Items from the DOE visit I'm uncertain about
or which may need updating

LArIAT Phased Program

Simulation of Antiproton Star in LAr

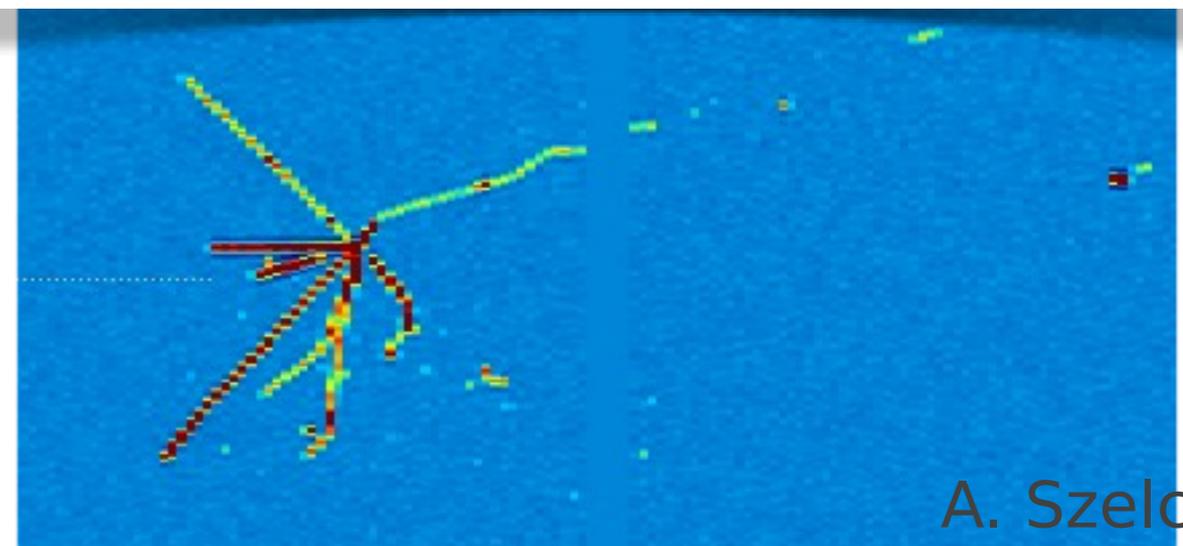
Don't know physics importance of this

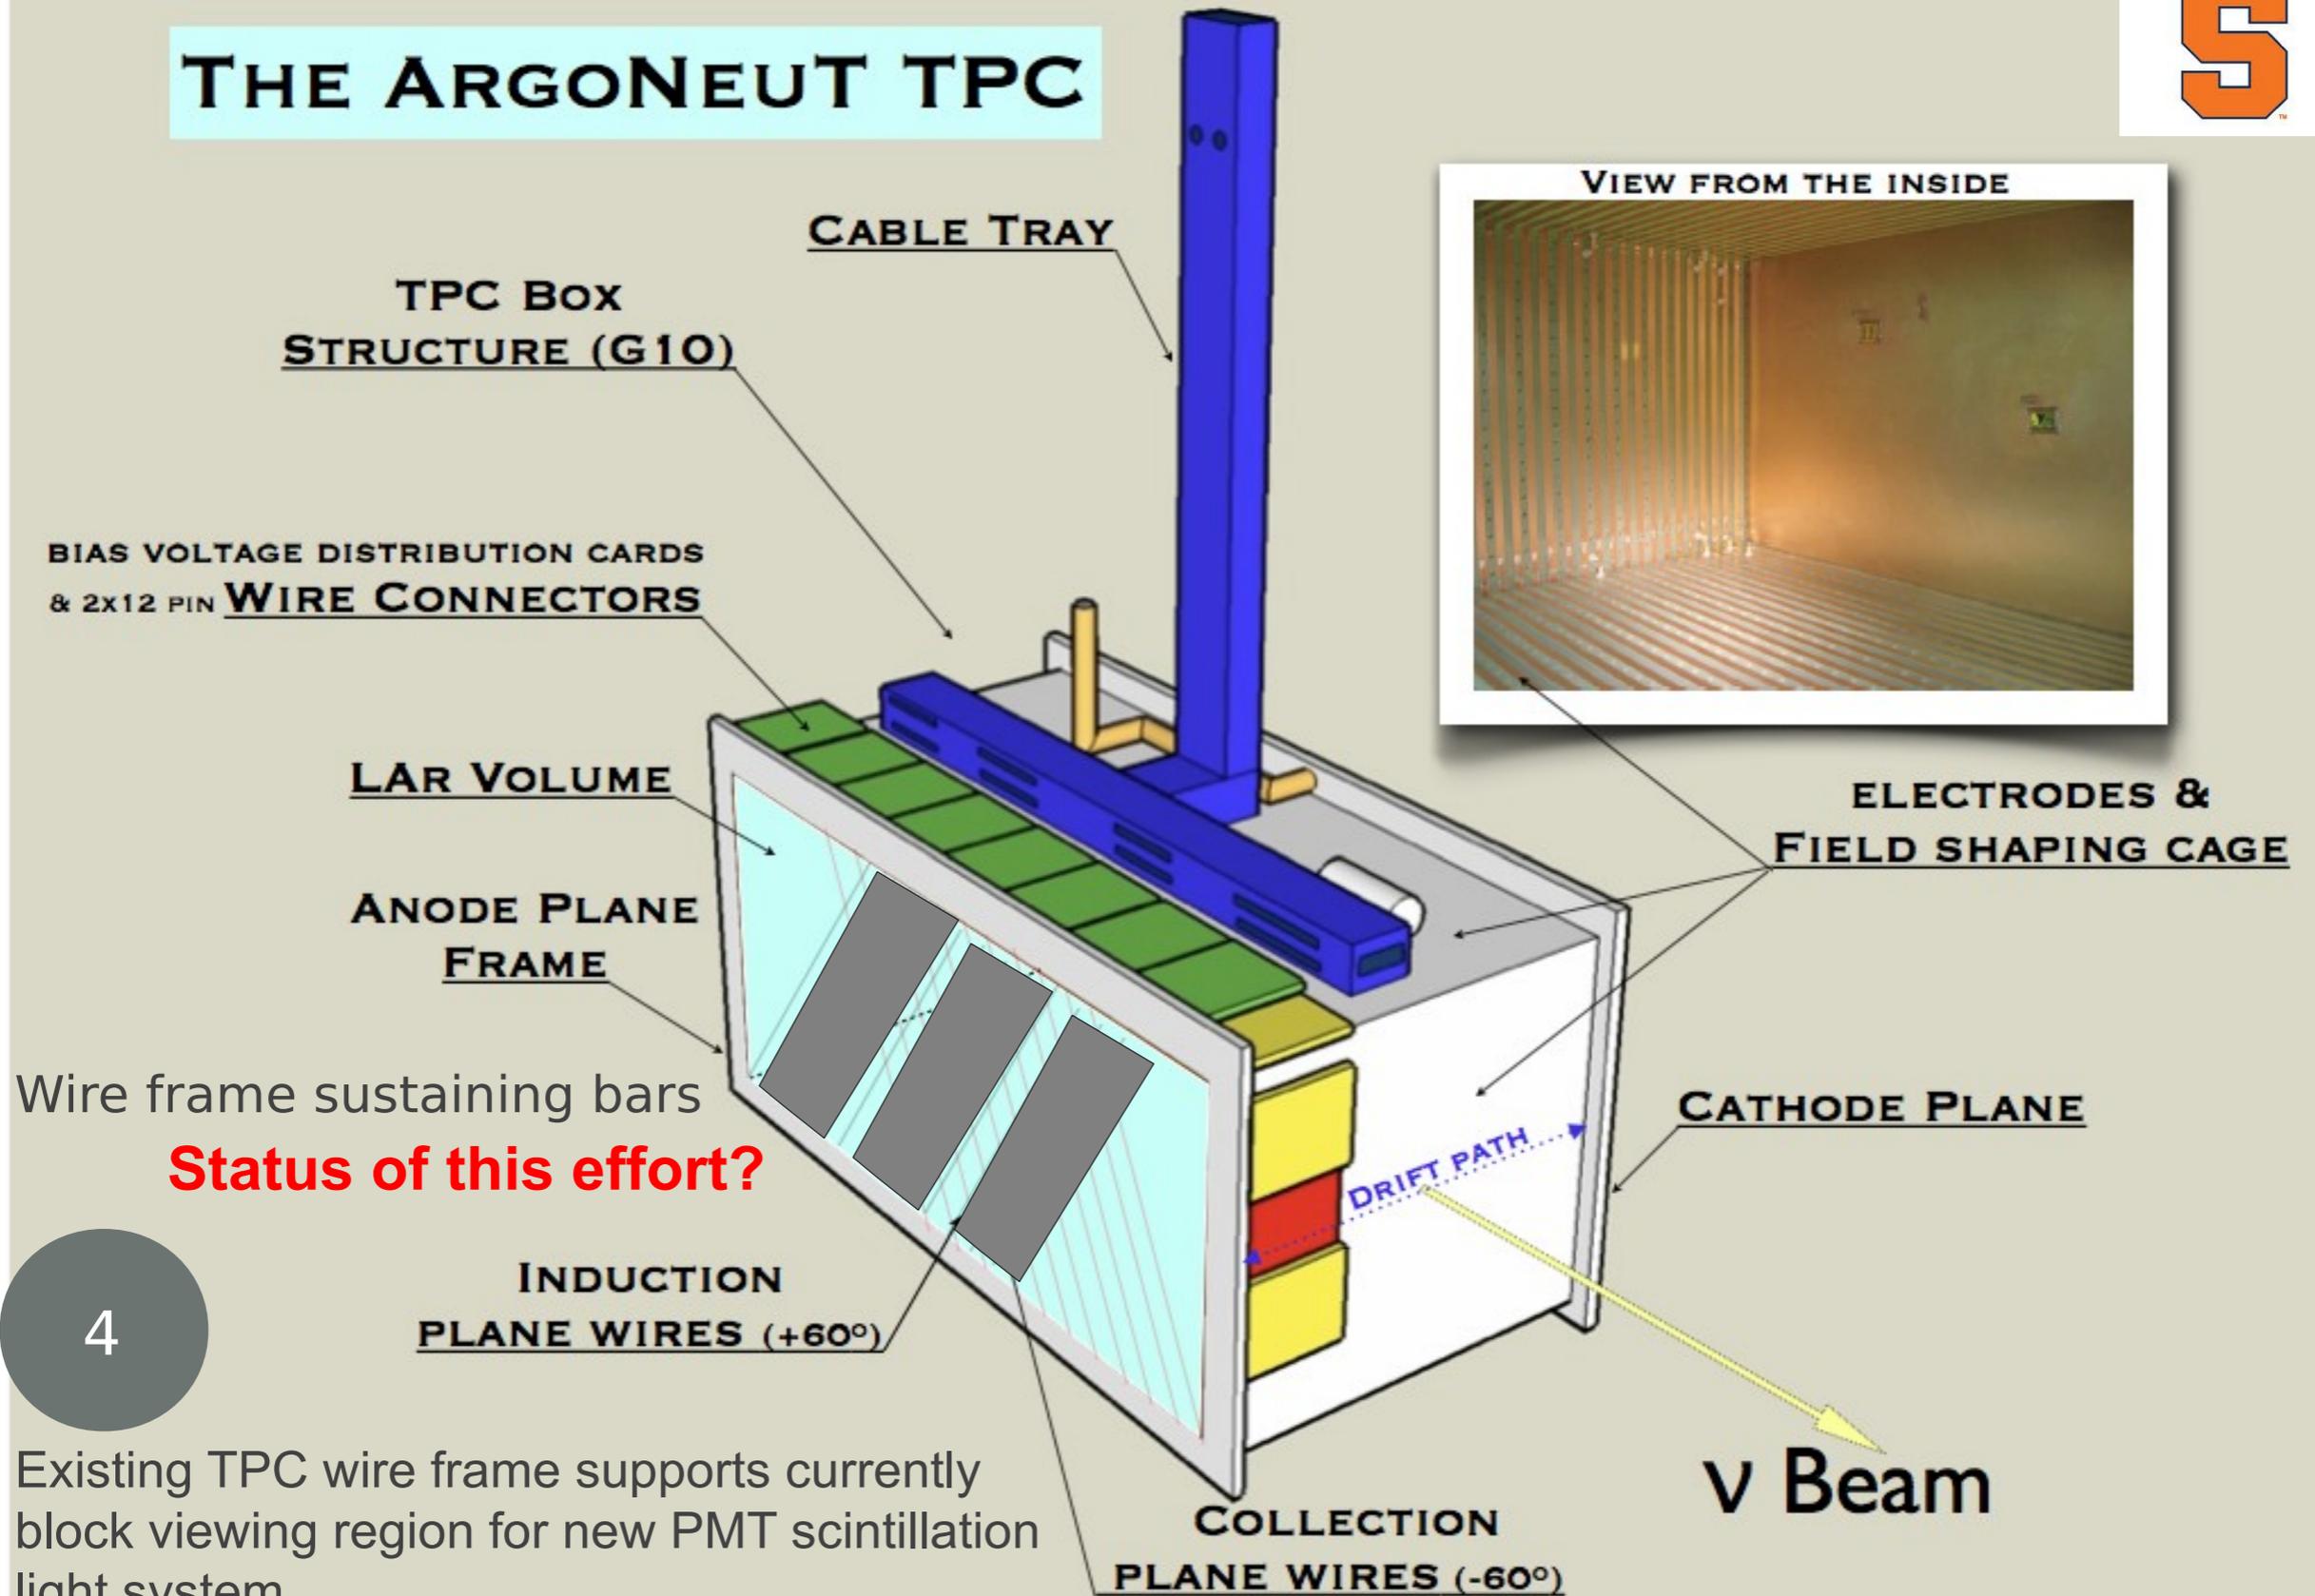
Needs updating?

Modification of Existing Components: TPC

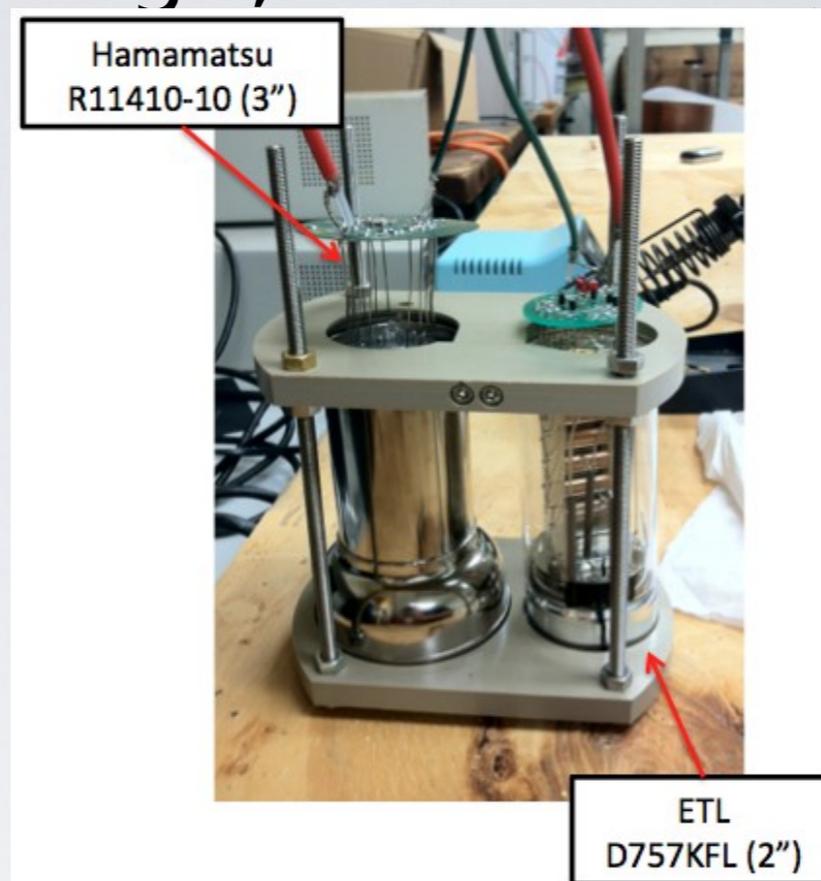
Wire frame sustaining bars
Status of this effort?

Existing TPC wire frame supports currently block viewing region for new PMT scintillation light system

Speed increase 1:

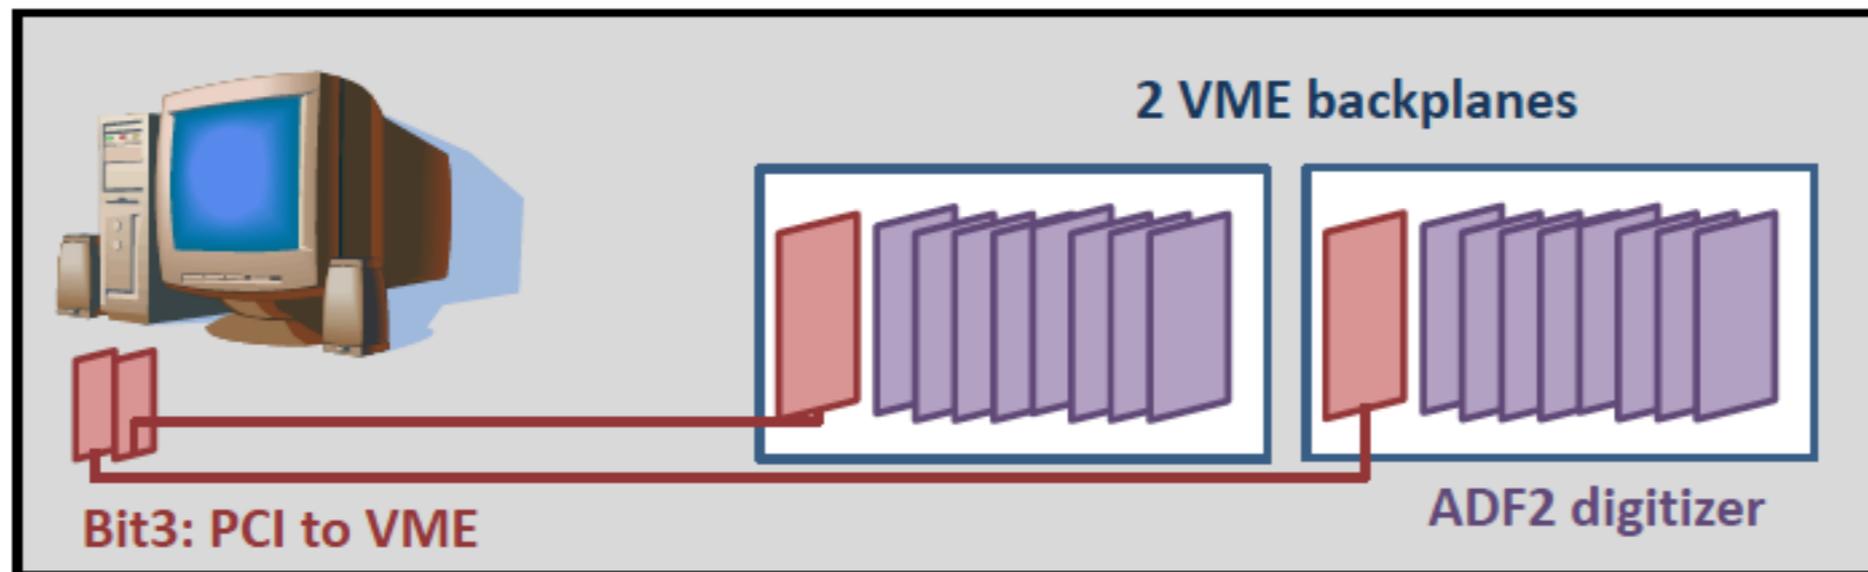
Still current?

Carl will discuss more later

Cryogenic & Purification System

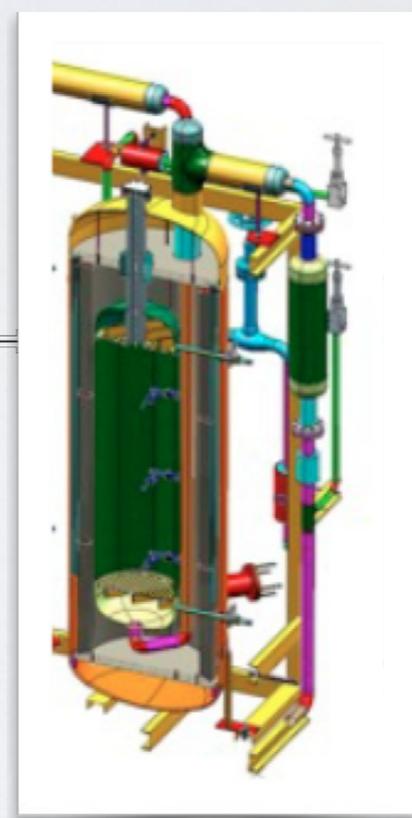
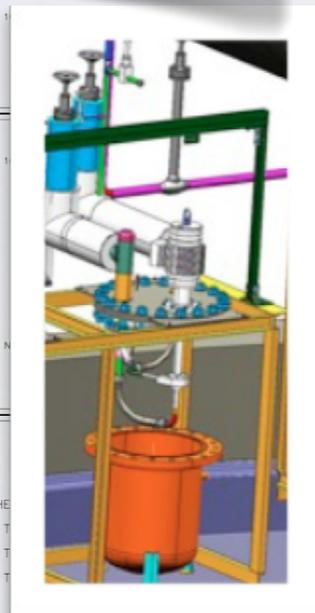
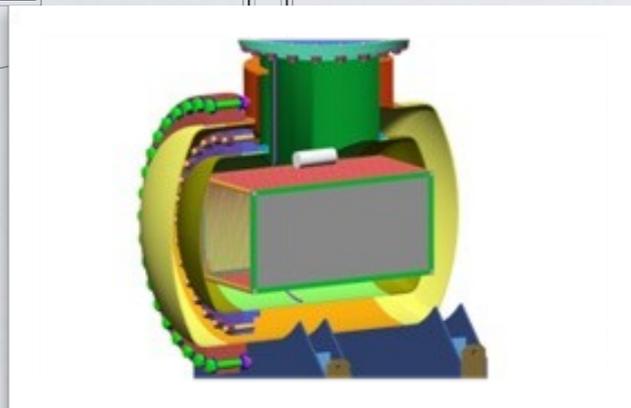
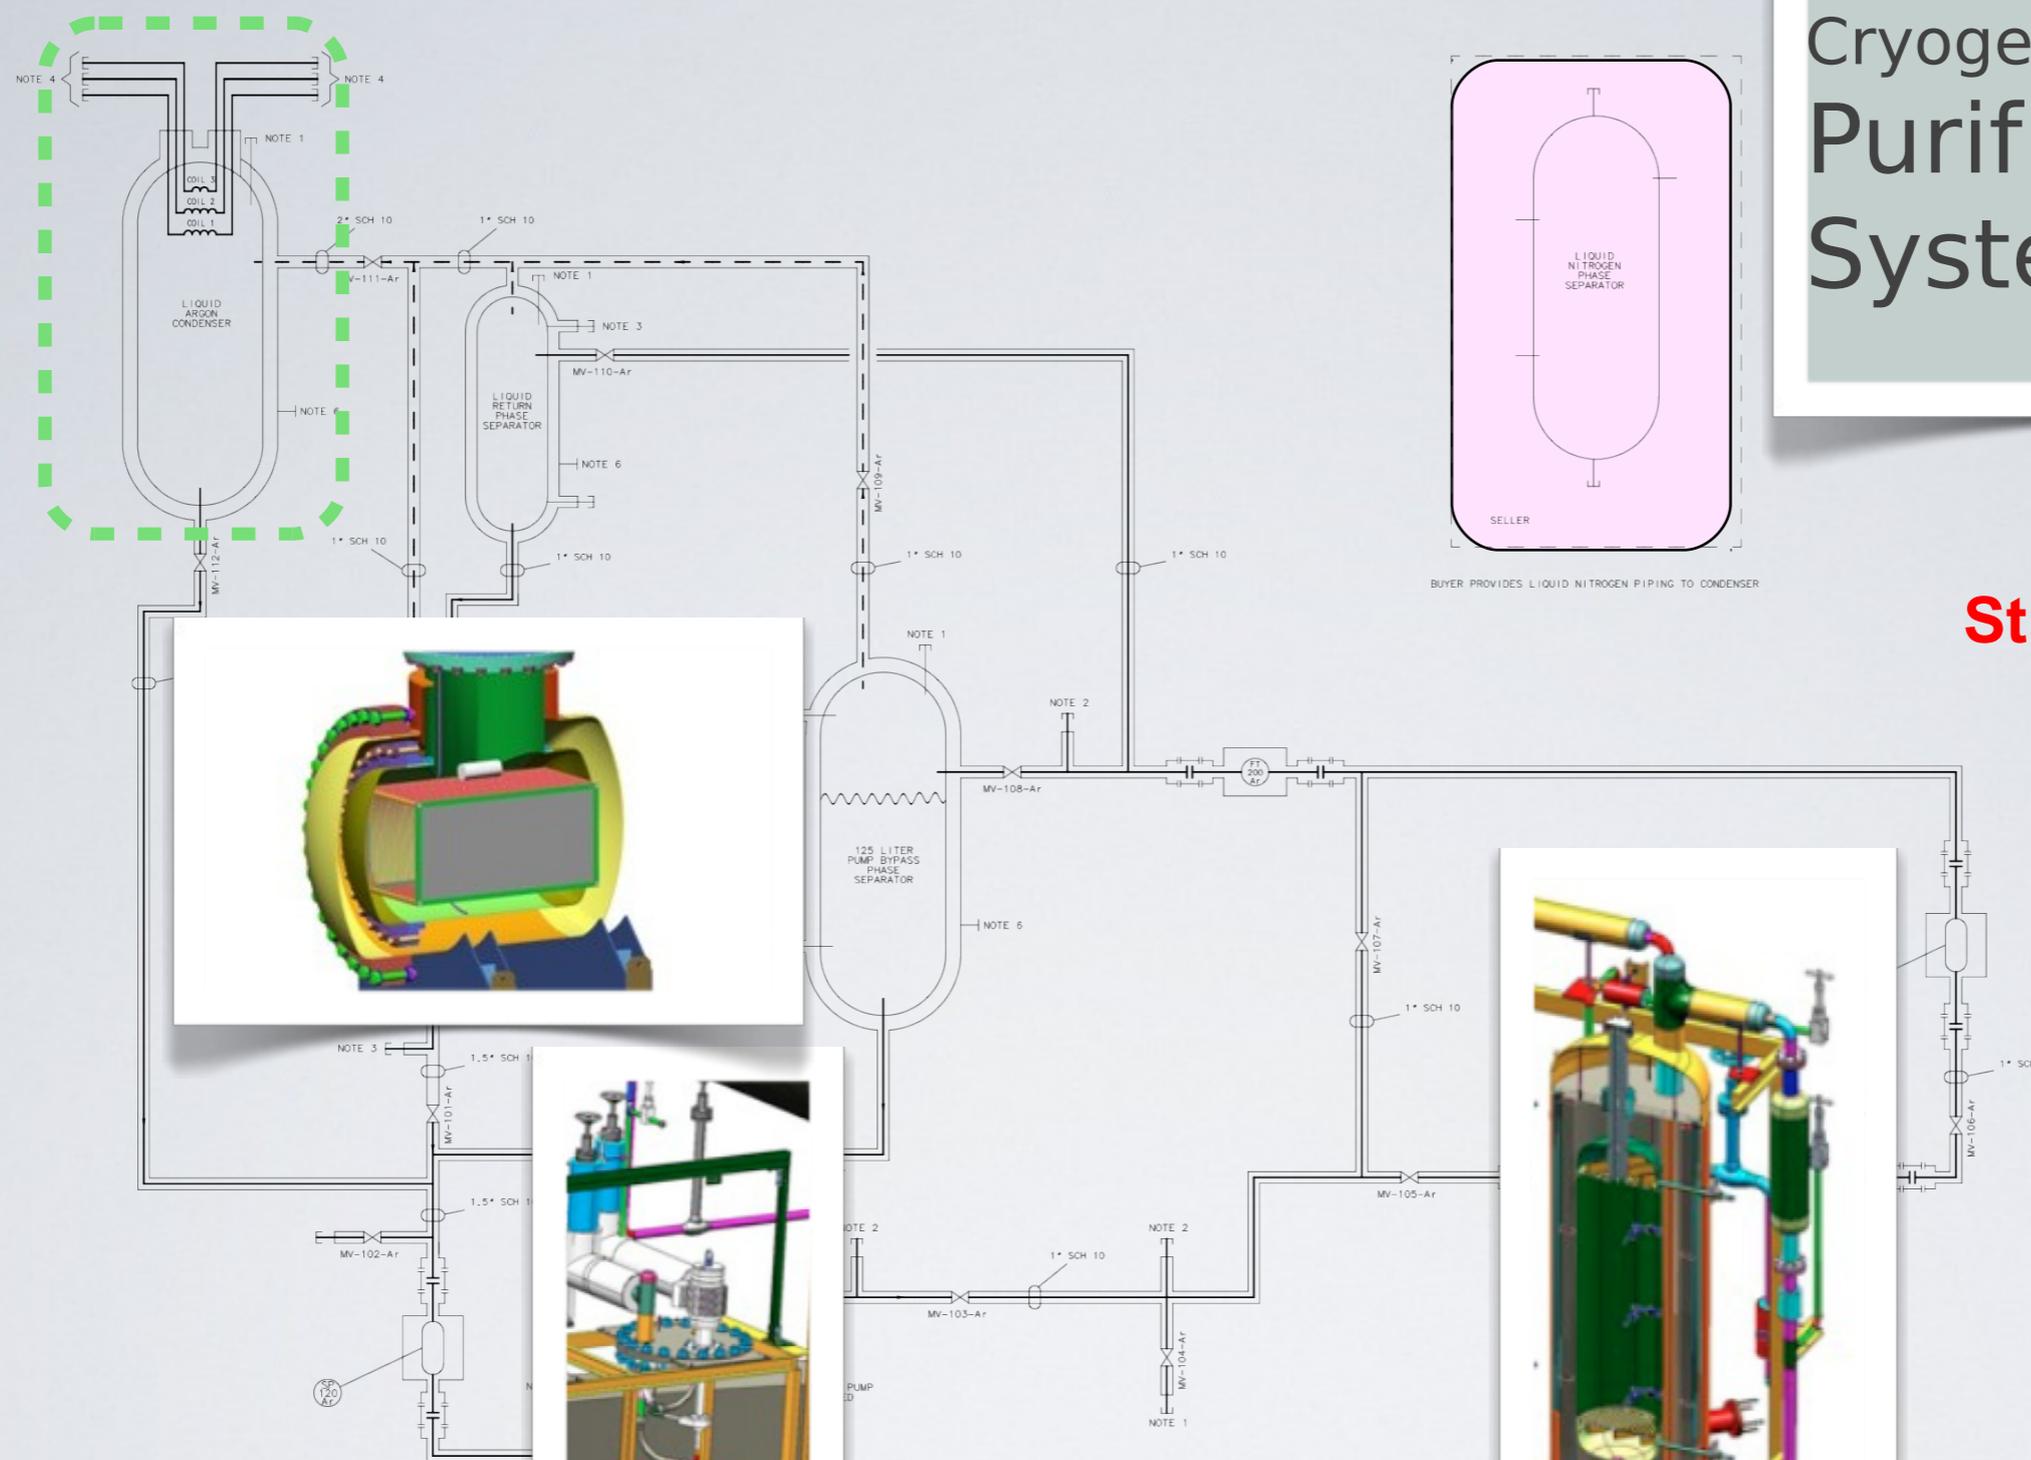
Still current?
